# METROPOLITAN GOVERNMENT OF NASHVILLE AND DAVIDSON COUNTY

## STAFF RECOMMENDATION 1910 Linden Avenue (aka 1908 Linden Avenue) November 20, 2013

**Application:** 1910 Linden Avenue (aka 1908 Linden Avenue)  
**District:** Belmont-Hillsboro Neighborhood Conservation Zoning Overlay  
**Council District:** 18  
**Map and Parcel Number:** 10416013200  
**Applicant:** Brent Craig, Rigid Development  
**Project Lead:** Melissa Baldock, melissa.baldock@nashville.gov

**Description of Project:** The applicant is proposing to construct a new two-story primary structure and a detached garage on a vacant lot.

### FRONT ELEVATION

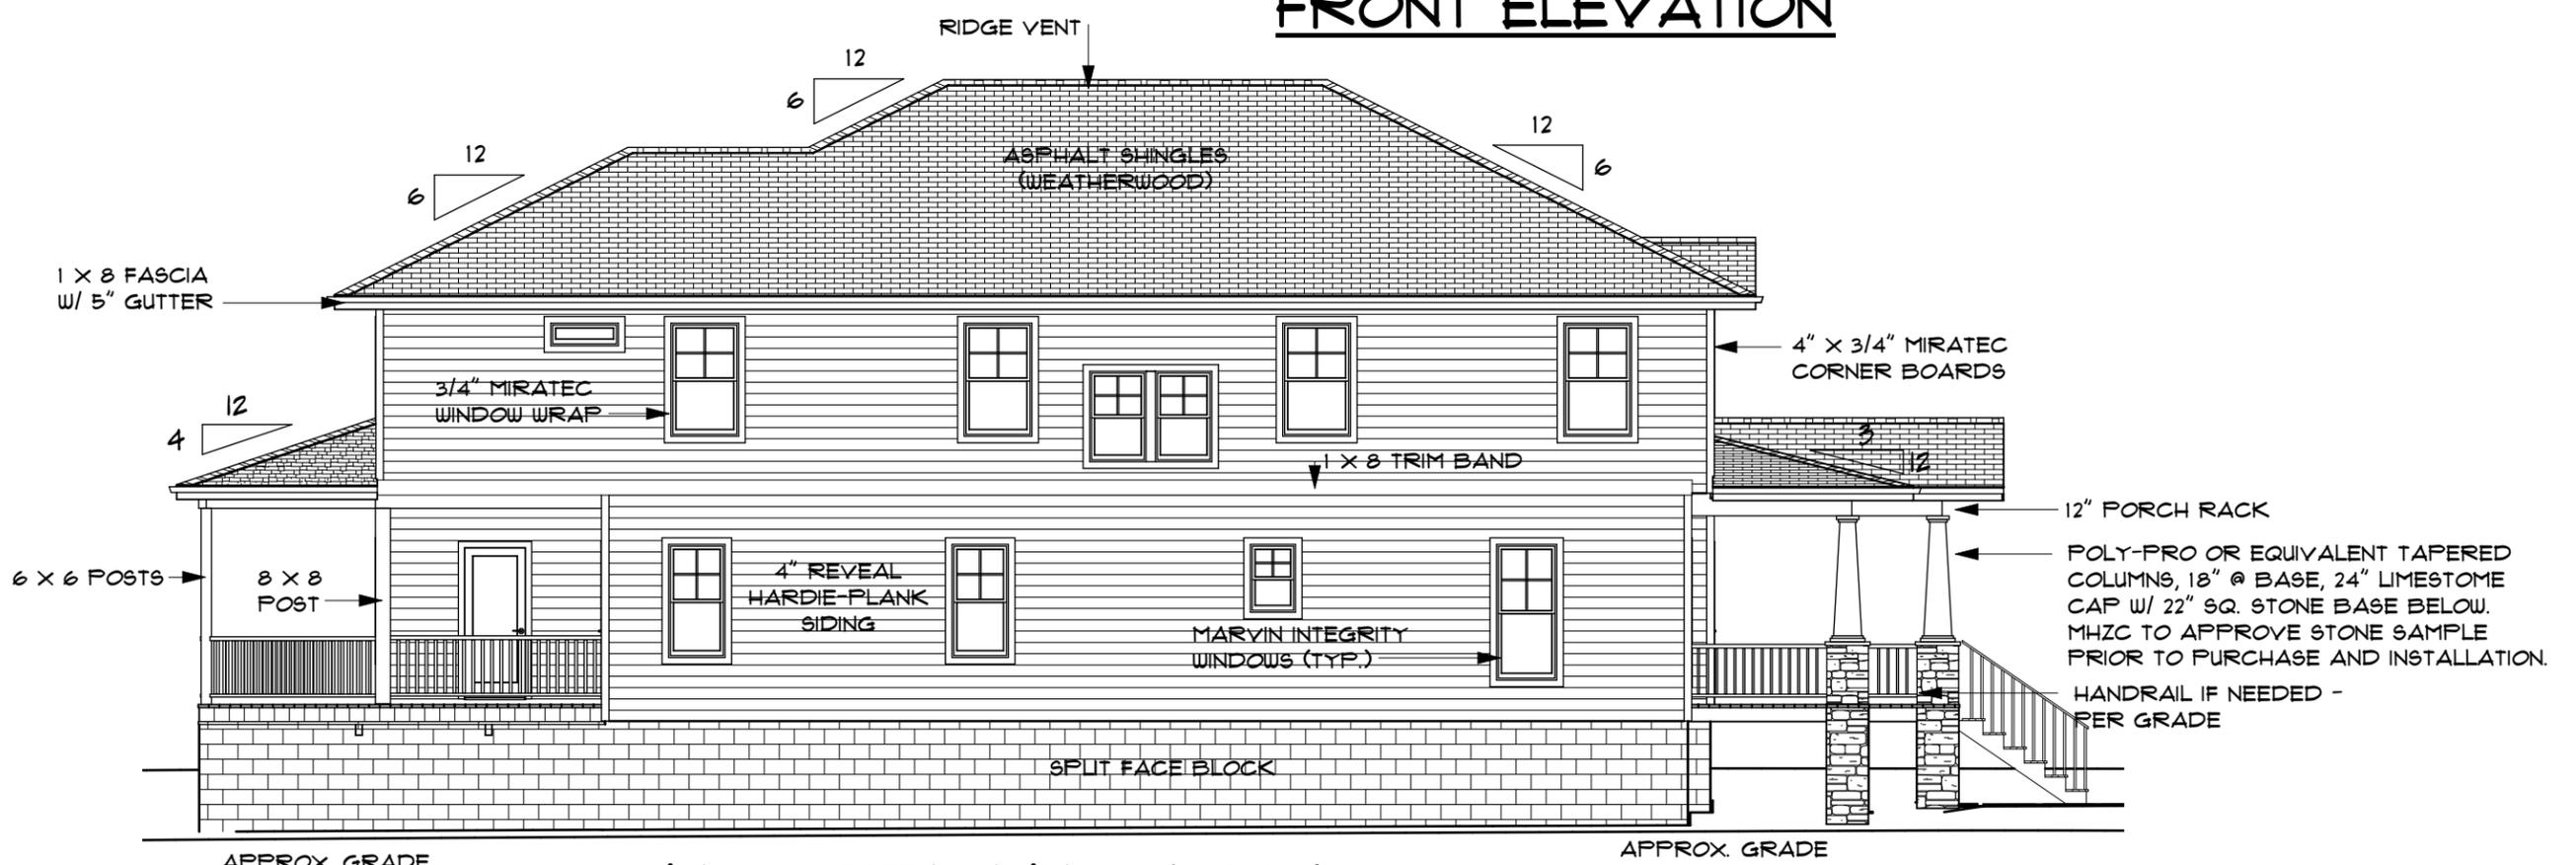
The house will have a ridge height of approximately thirty-two feet (32') from grade. This height meets the historic context; the house to the east at No. 1906 is approximately thirty-three feet (33') tall, and other two-story houses in the neighborhood range in height from thirty to thirty-five feet (30' - 35'). However, staff notes that the tall foundation at the front needlessly increases the height of the structure. The site has a cross slope to it, so the height of the foundation will vary at the front of the house. The drawings show a foundation height of approximately three feet, six inches (3'6") at its lowest point and four feet, six inches (4'6") at its highest point. Staff asks that a condition of approval be that the foundation height be lowered to be a maximum of two feet (2') at its lowest point.

Staff notes that the front porch is open below the porch floor level. As a result, the stone bases to the porch columns are unusually tall and out of scale with typical porch column bases. Staff asks that a condition of approval be that the porch have a typical foundation matching the foundation of the house, and the stone column bases end at the level of the porch floor.

1. The foundation height be reduced at the front so that it is a maximum of two feet (2') at its lowest point;
2. The porch have a typical foundation matching the foundation of the house, and the stone column bases end at the level of the porch floor;
3. The right elevation's second story bay be reduced in width or eliminated entirely;
4. Staff review the window and door specifications and a stone sample;
5. The shutters on the front façade's, second story central window be removed, or be designed that they are fully functional shutters.

### RIGHT SIDE ELEVATION

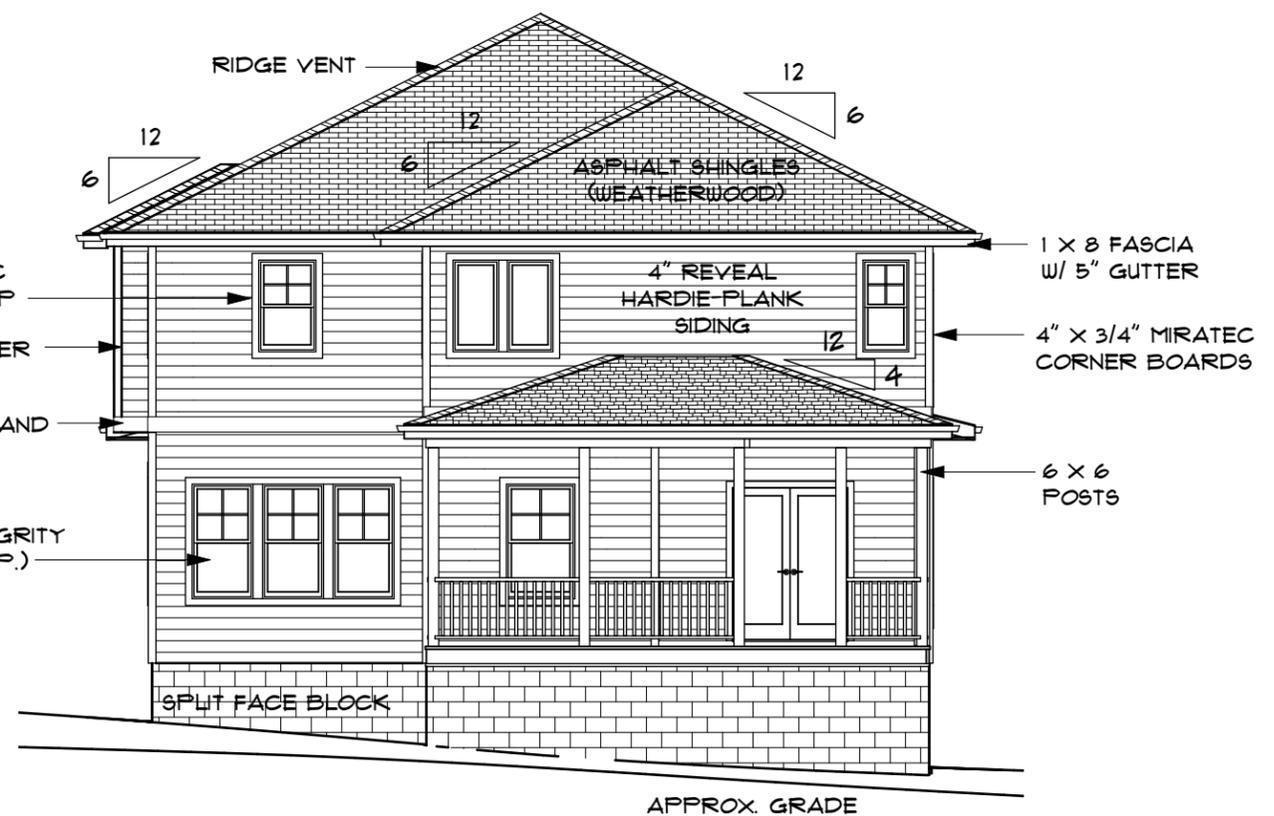
The right side elevation contains a double width projecting bay on the second story. Staff finds this bay to be out of scale with typical bays on historic houses. Staff asks that a condition of approval be that the bay's width be reduce or that the bay be eliminated.
